Office Action Summary	Application No. 10/528,052	Applicant(s) ARAI ET AL.	
	Examiner Jami M. Valentine, Ph.D.	Art Unit 2815

DETAILED ACTION

FIG. 1

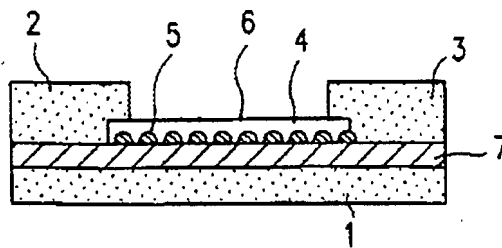
12. Per **Claim 1** Kado (e.g. figure 1) discloses a resistance-changing function body, comprising

- an object made of a first substance (4) and interposed between a first electrode (2) and a second electrode (3); and
- a plurality of particles (5) made of a second substance and arranged within the object so that an electrical resistance between the first electrode and the second

electrode is changed before and after application of a specified voltage to between the first electrode and the second electrode, wherein the first substance makes an electrical barrier against the second substance. (see column 6 lines 40-51)

14. Per **Claim 8** Kado (e.g. figure 1) discloses the fabrication of at least two memory resistance-changing function bodies as defined of claim 1, arranged in a direction parallel to a substrate (column 6 lines 27-36 discloses the patterning of multiple devices during one sputtering process.) as well as where the objects made of the first substance of memory cells mutually adjacent in the direction parallel to the substrate are integrally continuously formed (e.g. figure 1, see also column 6 lines 19-25)
